EDGE-ON-HUDSON

APPLICATION FOR SITE PLAN & SUBDIVISION APPROVAL

PHASE ONE SUPPLEMENTAL SUBMISSION

Re: Phase 1 Site Plan and Subdivision Application
Edge-On-Hudson Riverfront Development
199 Beekman Avenue, Sleepy Hollow

SP-1.2

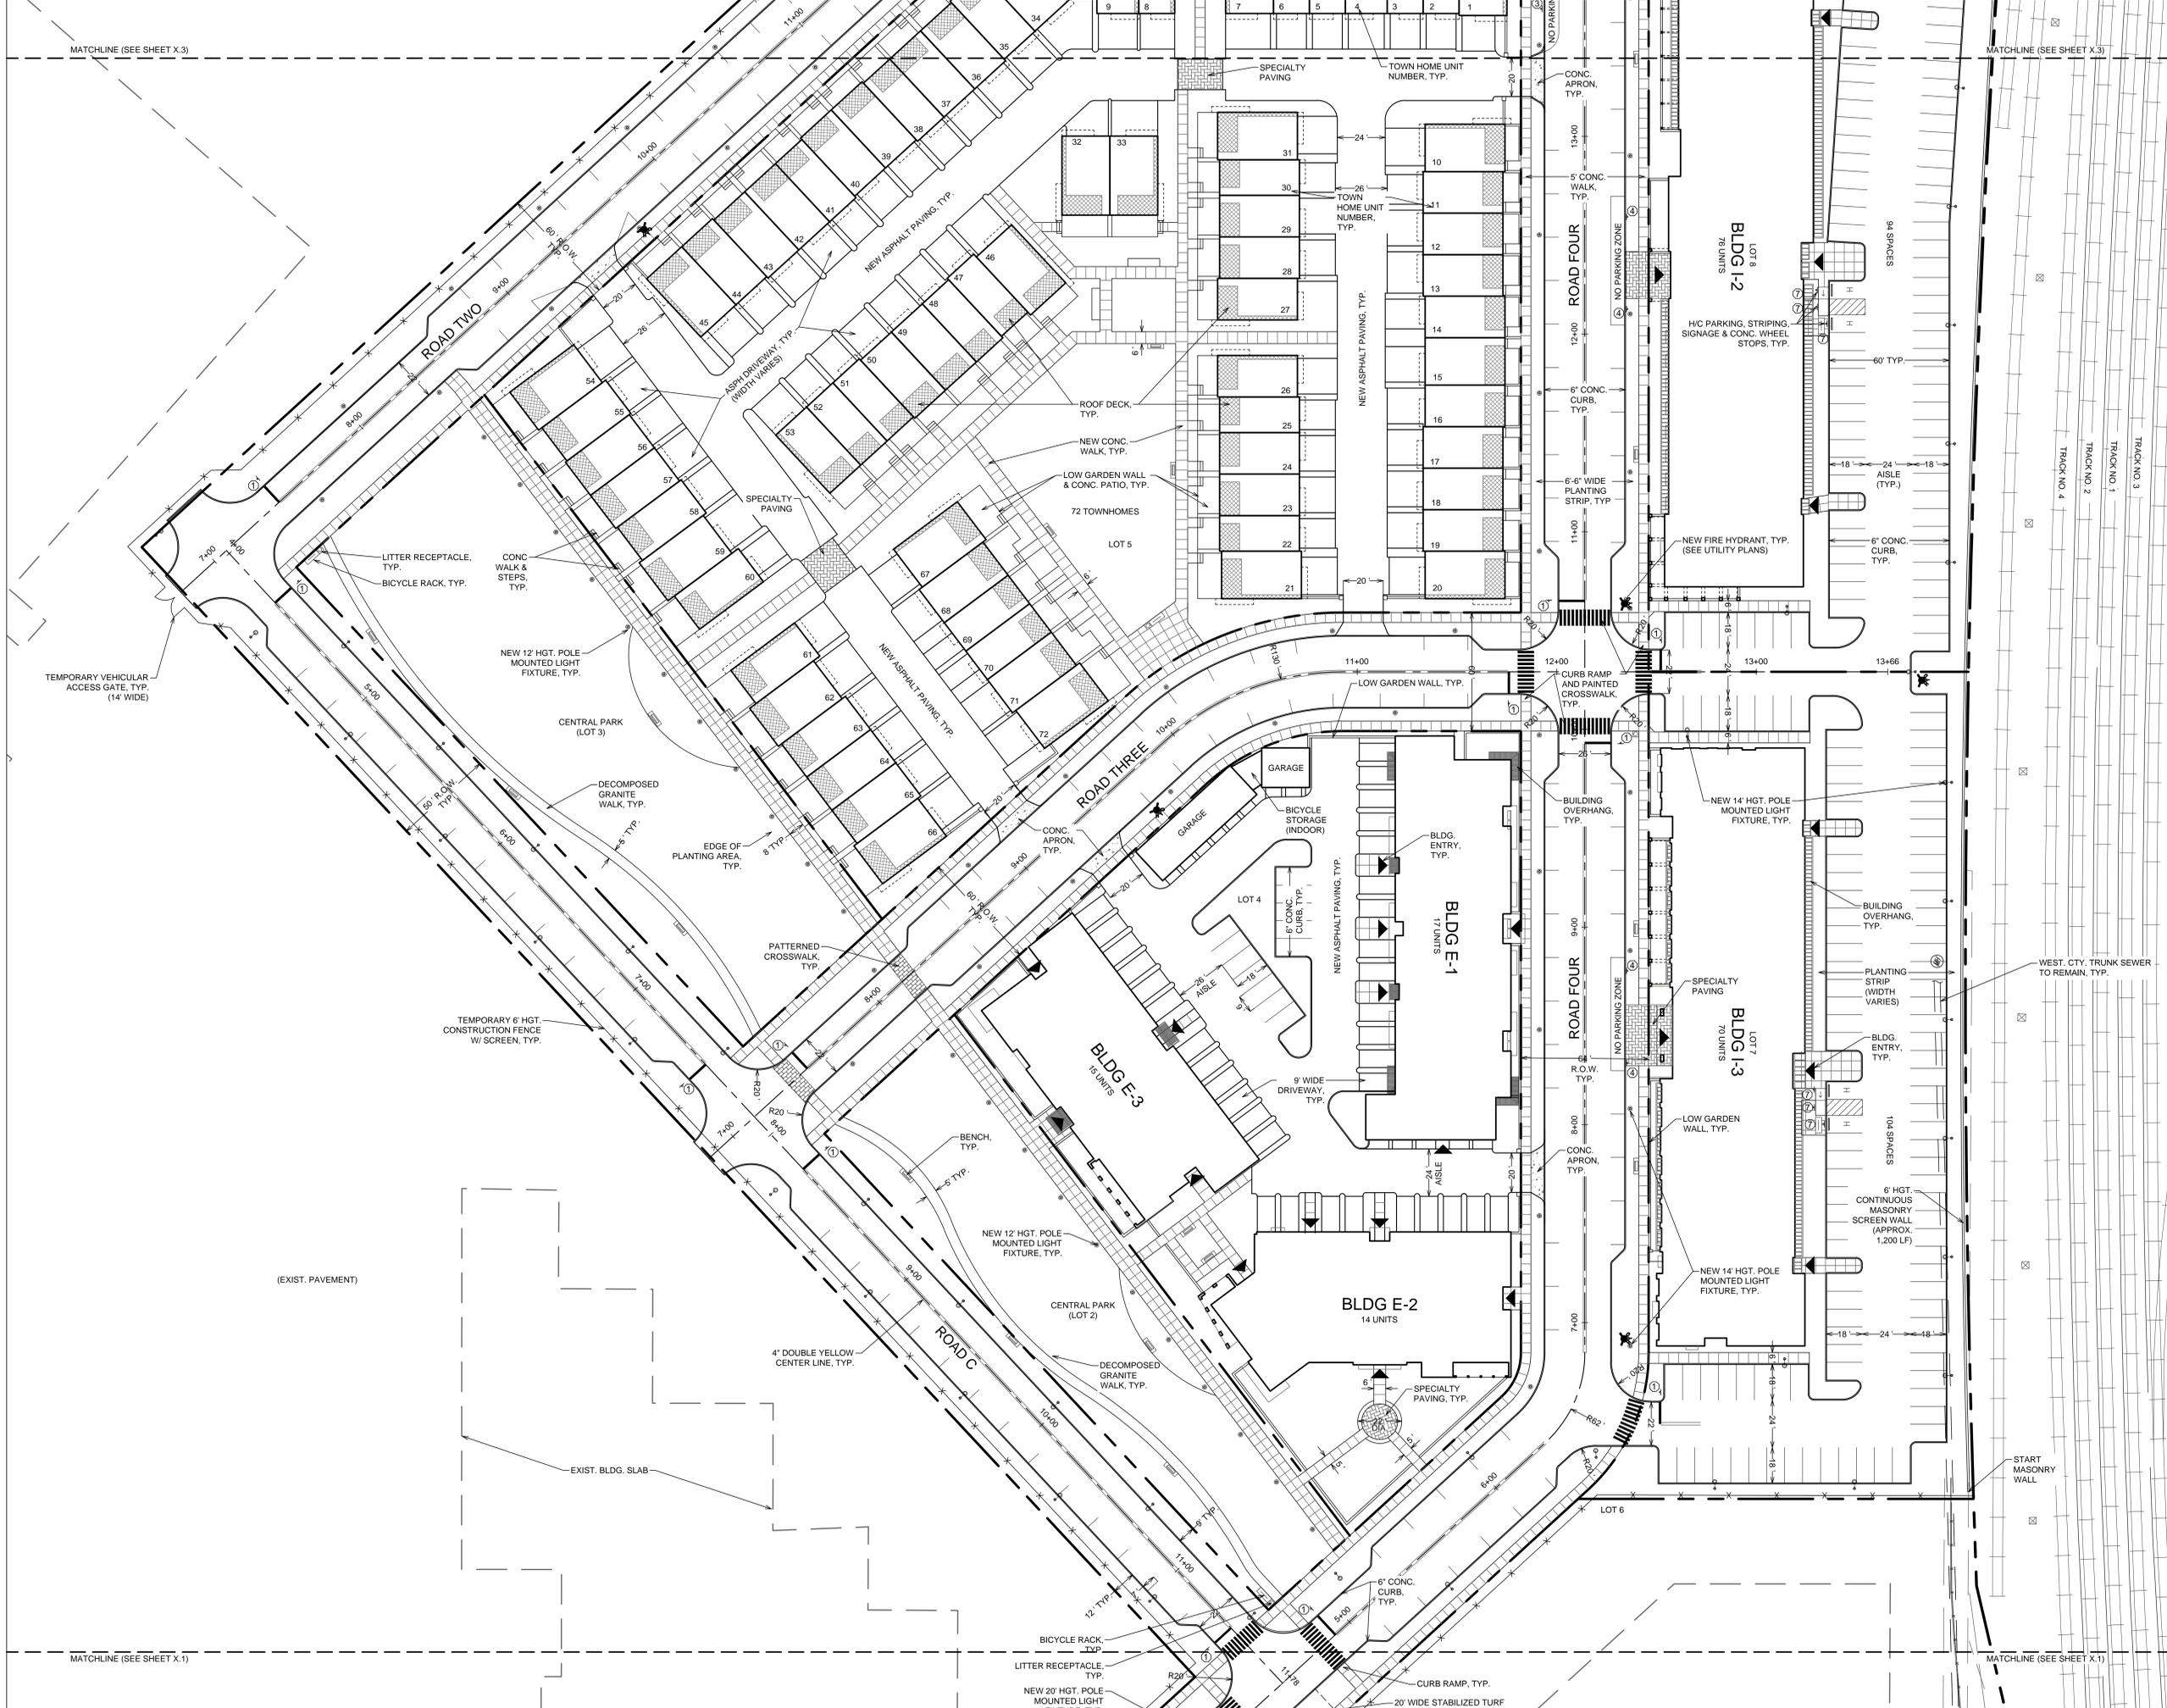
G5. **Comment** *The limit of concrete slab saw cutting for Phase I must be indicated on the plan.*

G7. **Comment** *A detail for granite curbs has been provided. Plans indicate concrete curb in some locations and the curb material is not specified in others. Where are these proposed?*

Response The Applicant intends to demolish all concrete building slabs within the site during the first phase of construction. The approximate location of interim saw cut lines for the required Phase I Site Plan slab demolition area are shown on Sheets SP-1.1 through SP-1.3.

Response Granite curbing is proposed to be used within all public right-of-way areas and the Block E center court area. All other curbing will be concrete. Refer to Sheets SP-1.1 through SP-1.3 for the updated Site Layout Plans.

SP-2.1

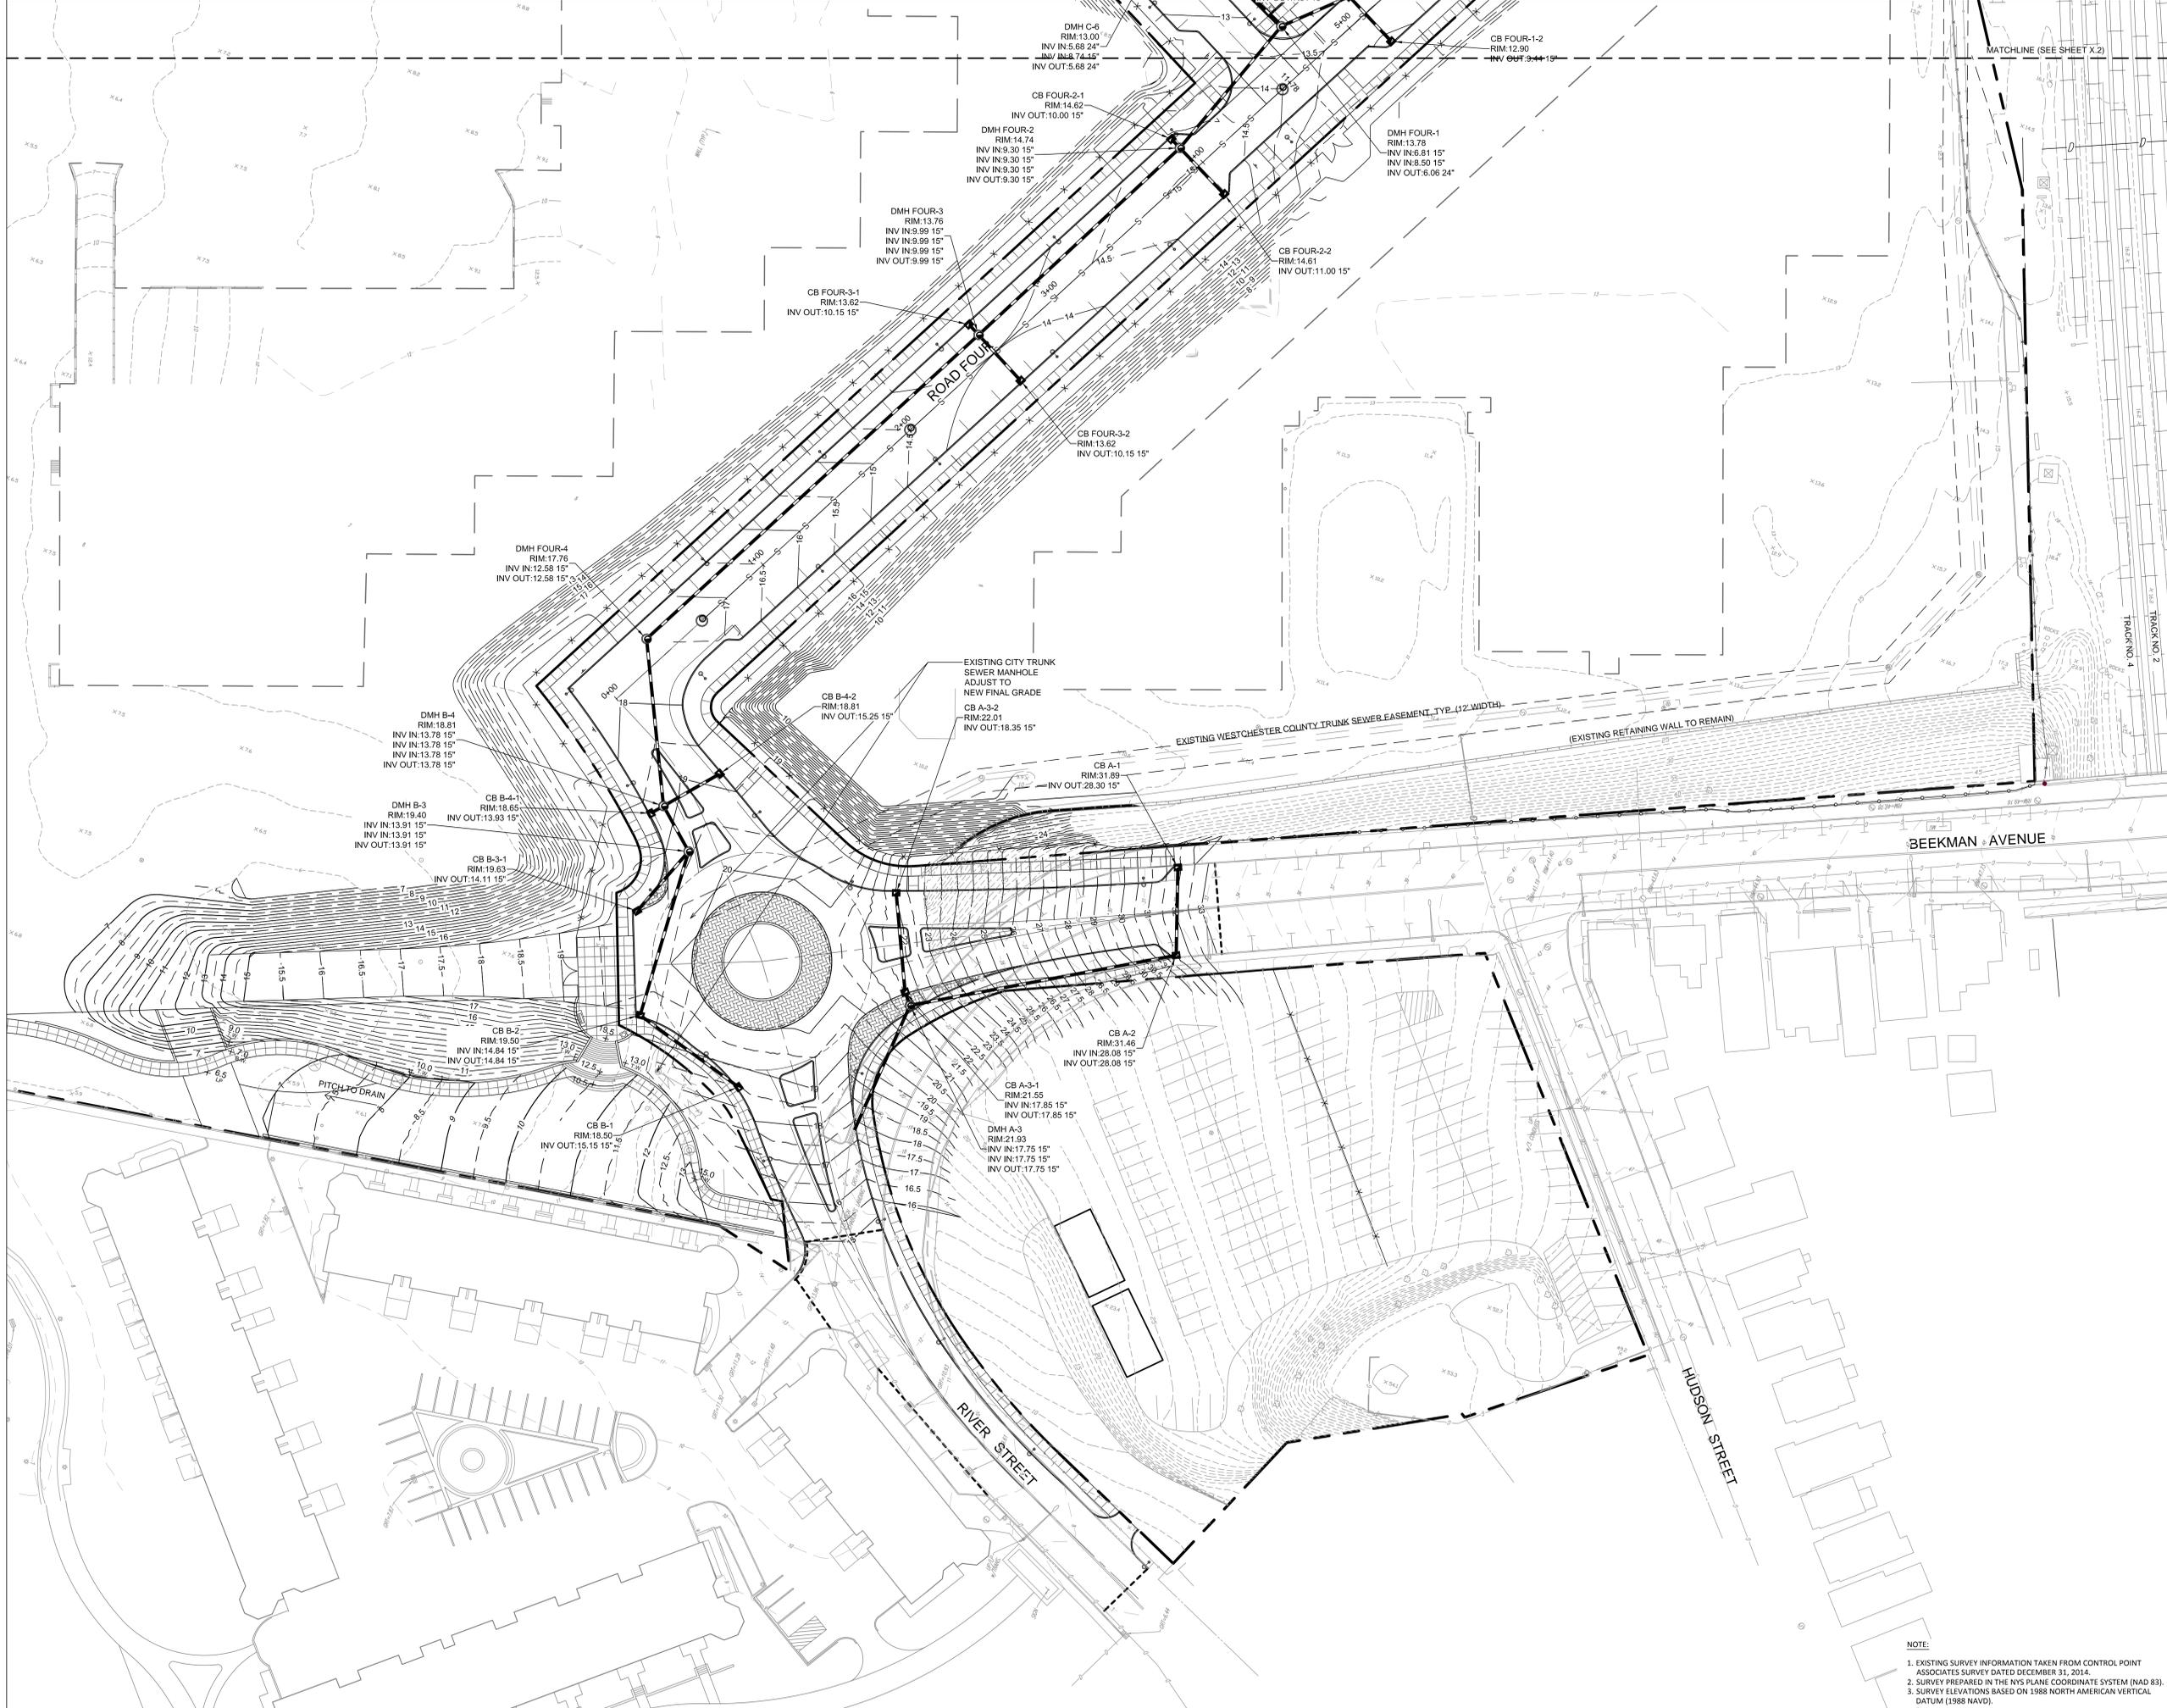
U2. **Comment:** *Will existing County sanitary sewer manhole rims within Phase I and in the Beekman Avenue and Road Four rights of way need to be adjusted to accommodate grade changes?*

GR1. Comment: *How will the proposed grading along Road Four and the rotary tie into the existing topography to the north of Beekman Avenue?*

GR2. Comment: *Proposed grading must be labeled more clearly. Spot elevations should be added at all high points and low points on the grading plan, both in the roadways and landscaped areas.*

S1. **Comment:** *In order to prevent the re-suspension of deposited sediments in catch basin sumps, after two catch basins in series the stormwater system must tie into a central drain line.*

- Response:** Yes. Notes have been added to the Site Plan Drawings SP-2.1 and SP-3.1 requiring those County Trunk Sewer manholes affected by construction to be “raised to grade” to meet the new proposed finished grade elevations.

Response: The grading shown on the *Phase I Grading & Drainage Plan*, Sheet SP-2.1 has been revised to indicate the tie into the existing topography.

Response: Additional spot elevations have been added to the Grading and Drainage Plans, Sheets SP-2.1 through SP-2.3, and the half-foot contour labels are now clearly identified.

Response: Comment noted. The Applicant has revised its storm drainage collection system to incorporate a central drain line. Refer to the revised *Phase I Grading & Drainage Plan*, Sheets SP-2.1 through SP-2.3.
